AGENDA
PLANNING BOARD
MEETING TIME 6:30 PM - MAIN MEETING ROOM
JANUARY 7, 2026

DATE: December 26, 2025
BOARD: Planning Board
APPLICATION: Christian Brothers Academy (#2025-206)
850 Newman Springs Road - Christian Brothers Academy
Block 1063, Lot 67.01
Minor Site Plan

Re: Varsity Gymnasium Air Conditioning
Christian Brothers Academy
850 Newman Springs Road
Block 1063, Lot 67.01
Minor Site Plan
First Engineering Review

NORTH ELEVATION

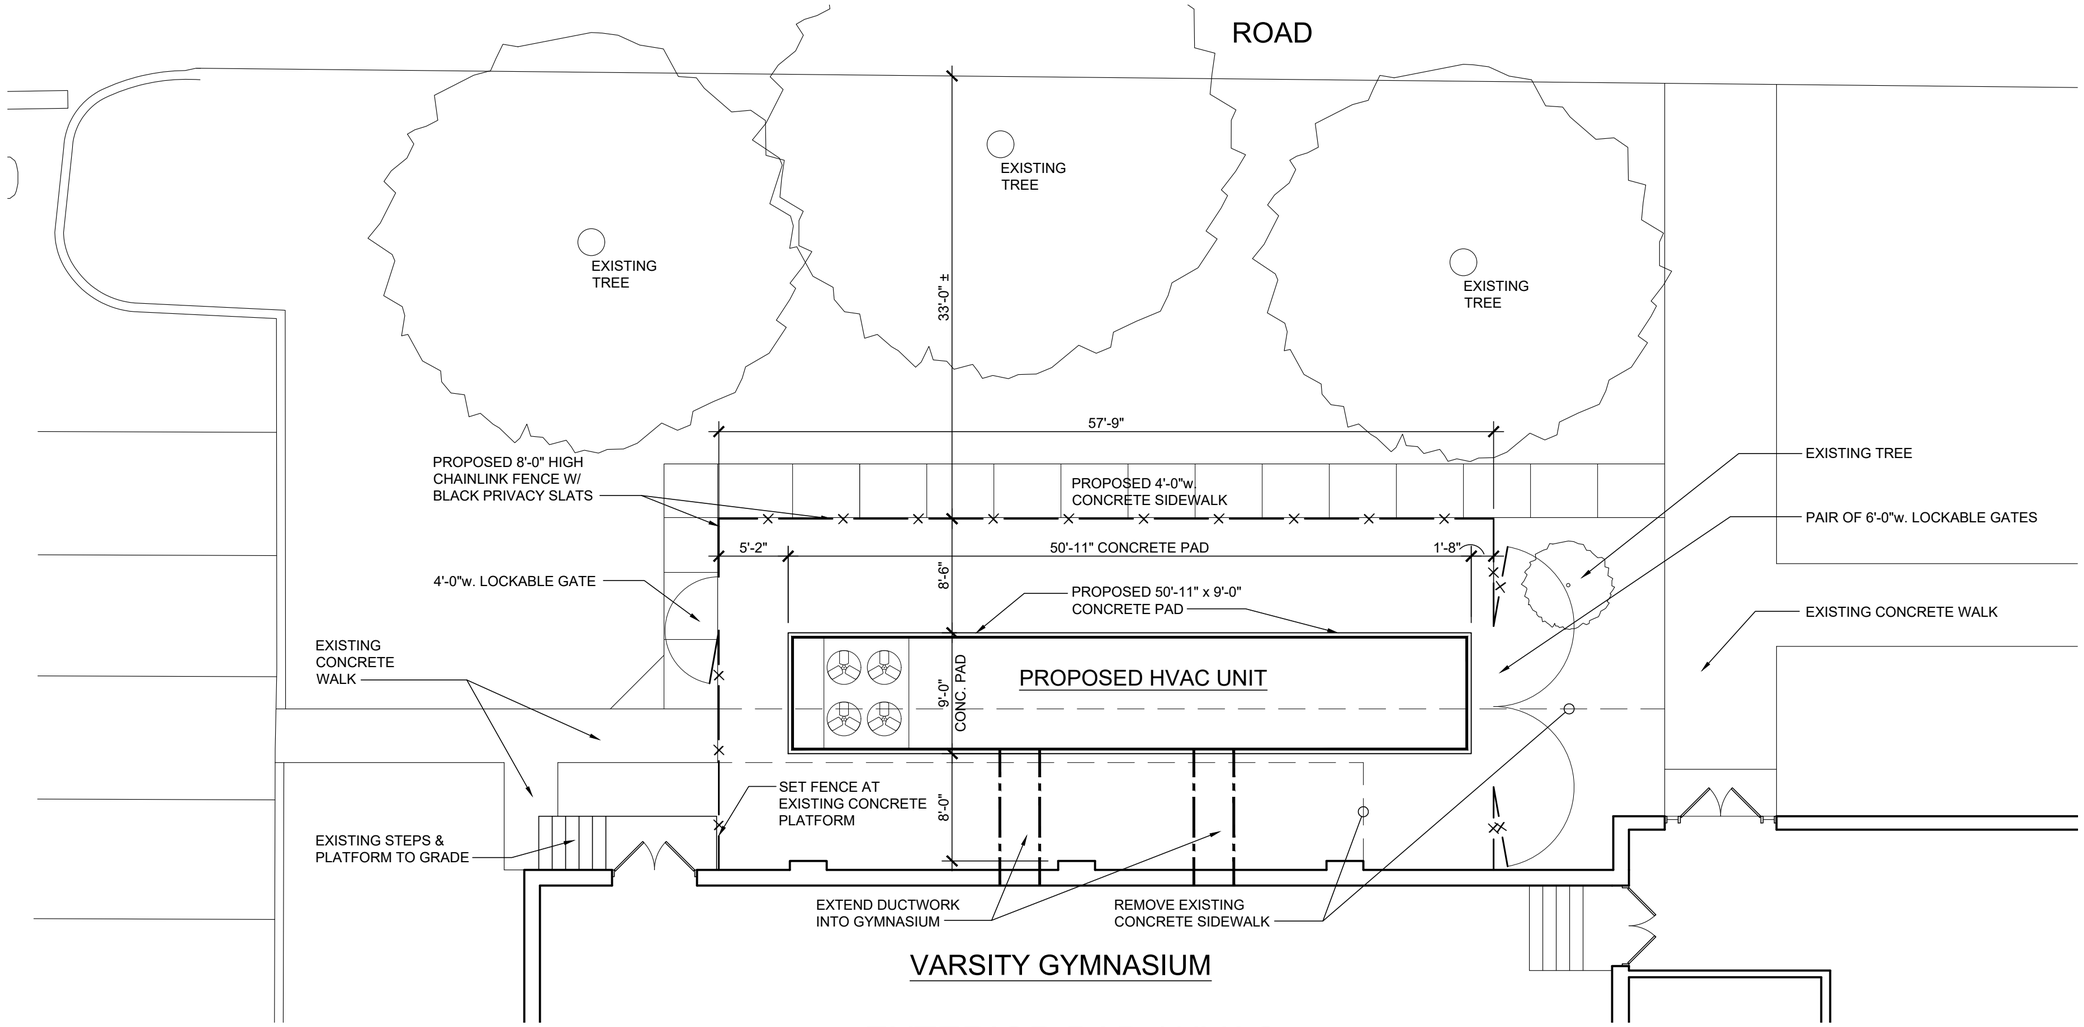
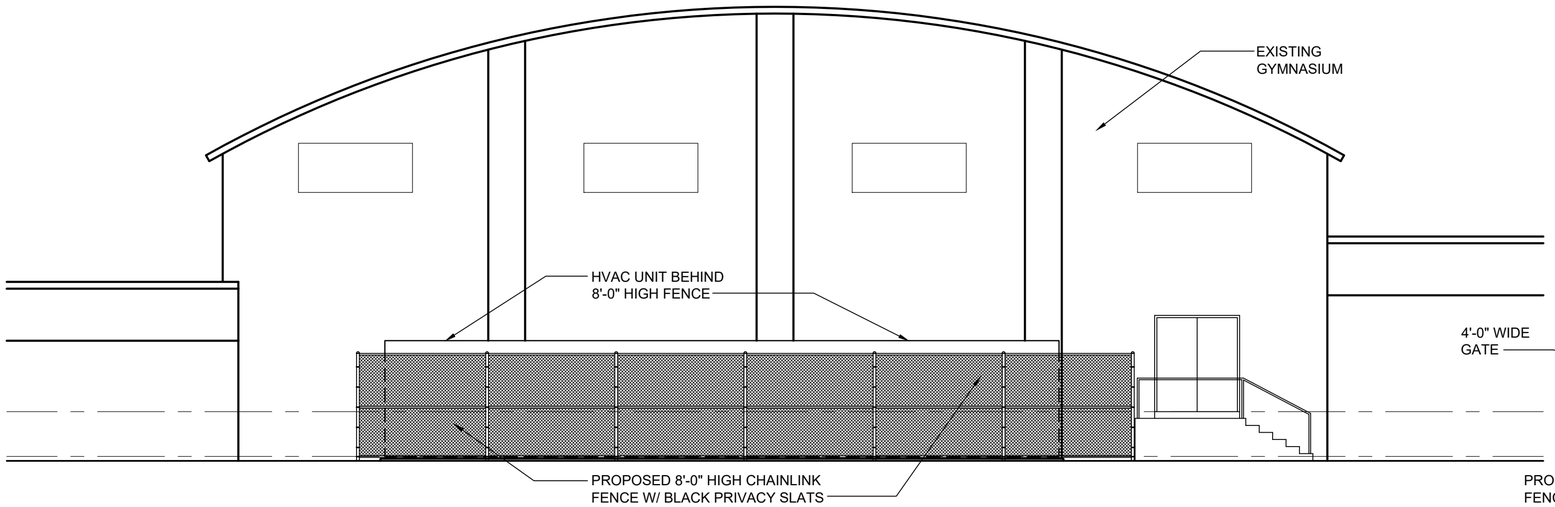
1. The applicant should clarify the height of the proposed HVAC unit. We note that as the unit is to be screened by an 8'-0" high chain link fence with privacy slats and the architectural elevation views indicate the unit will be slightly taller than the fence.
